Work Order ID 108704

Item Name: Aft Crosstube

| TITLE CROSSTUBE ASS'Y (407 HIGH AFT) | SCALE NTS |

| DRAWING NO. D407-667-245 | | TITLE CROSSTUBE ASSY (407 HIGH AFT) | | REV. F | | DART AEROSPACE LTD ENGINEERING ORDER | | D.E.O. NO. D407-667-245-F-1 | | SHEET NO. SHEET 1 OF 2 | | SCALE NTS | |

| DRAWING NO. D407-667-245 | TITLE CROSSTUBE ASSY (407 HIGH AFT) | REV. F | DART AEROSPACE LTD ENGINEERING ORDER | D.E.O. NO. D407-667-245-F-1 | SHEET NO. SHEET 2 OF 2 | SCALE NTS |

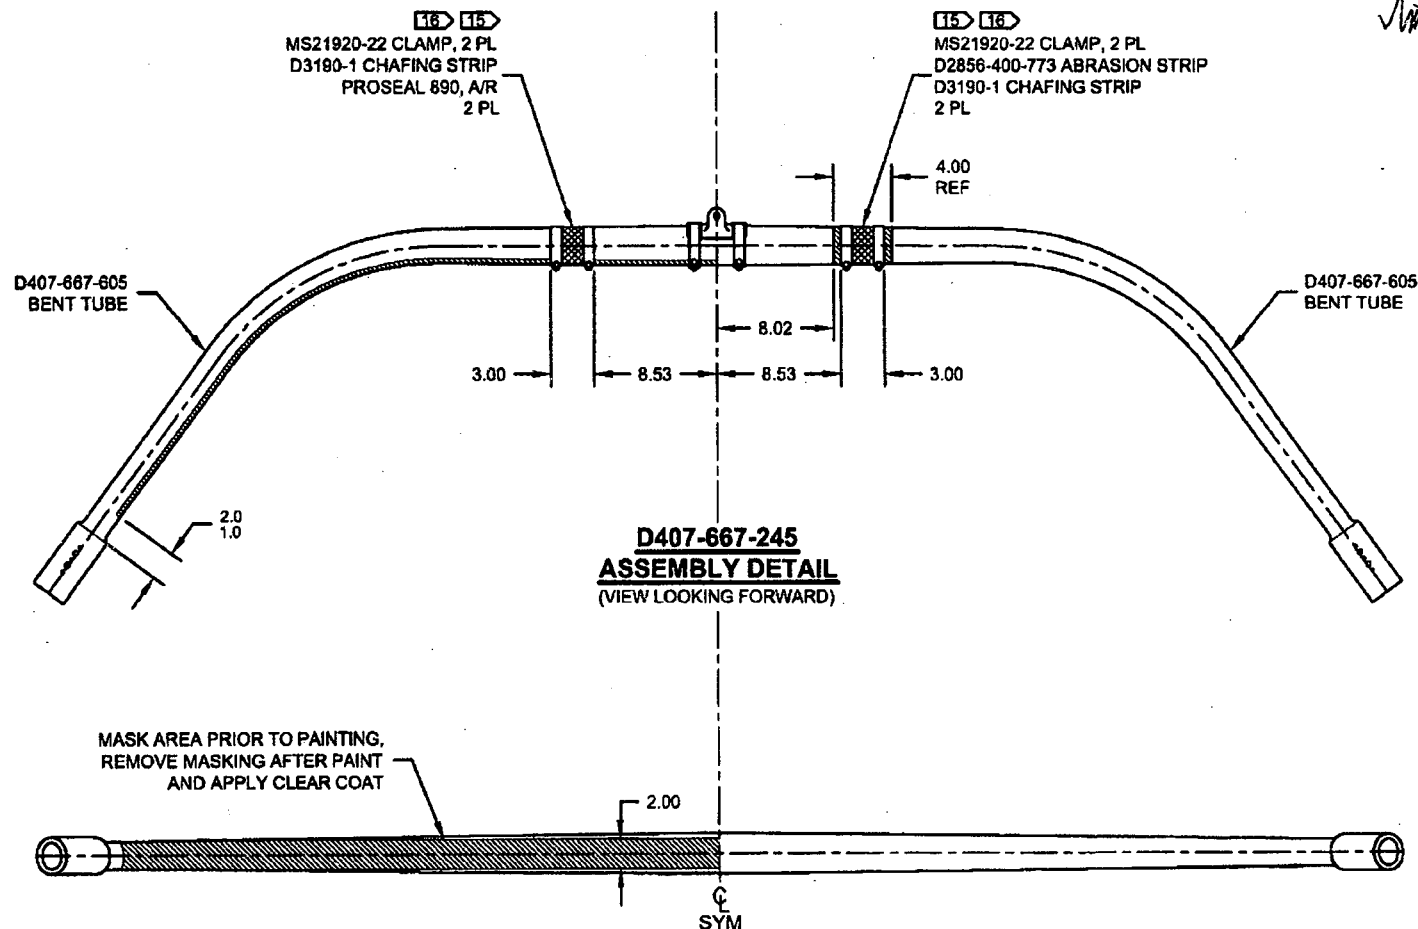
NOTES 2 AND 15, SHEET 1 ARE AMENDED AS FOLLOWS:

- 2) FINISH: CHEMICAL CONVERSION COAT PER DART QSI 005 4.1
PRIME INSIDE AND OUTSIDE PER DART QSI 005 4.2
MASK UNDERSIDE OF CROSSTUBE AS SHOWN (HATCHED AREA) AND
PAINT OUTSIDE PER DART QSI 005 4.2
REMOVE MASKING AND APPLY CLEAR COAT
- 15) APPLY A THIN COAT OF PROSEAL 890 ON INSIDE CONCAVE SURFACE OF D3190-1
CHAFING SHIELDS AND LET CURE PER MANUFACTURER'S INSTRUCTIONS. INSTALL
PROSEALED D3190-1 CHAFING SHIELDS ONTO CROSSTUBE BY APPLYING A THIN COAT
OF PROSEAL 890 ONTO CROSSTUBE. BE SURE TO ELIMINATE ANY AIR GAPS.

FIGURE 1 - INSTALLATION OF DART CROSSTUBES ON BHT/AAI SKIDTUBE

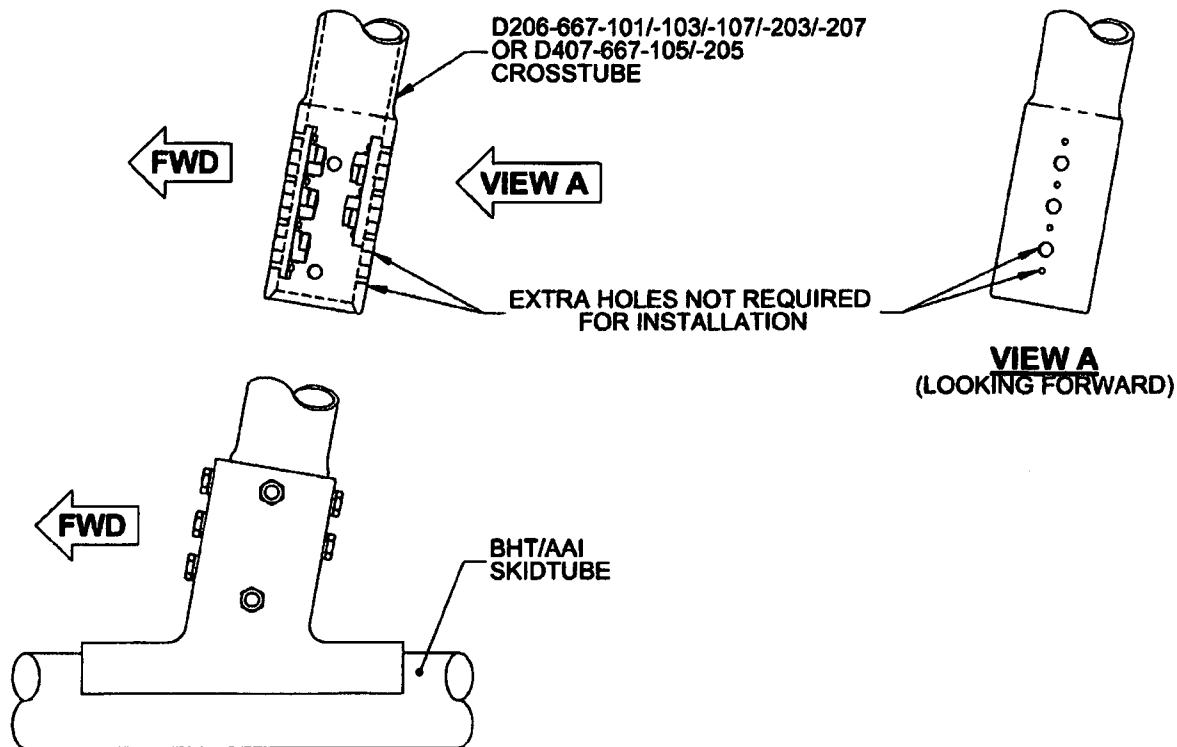
THE FOLLOWING D206-667-101/-103/-107/-203/-207 AND D407-667-105/-205 CROSSTUBES HAVE EXTRA HOLES DRILLED ON THE AFT SIDE OF THE CUFFS. THIS HOLE IS NOT REQUIRED FOR INSTALLATION OF DART CROSSTUBES ONTO BHT/AAI SKIDTUBES AS SHOWN IN FIGURE 1.
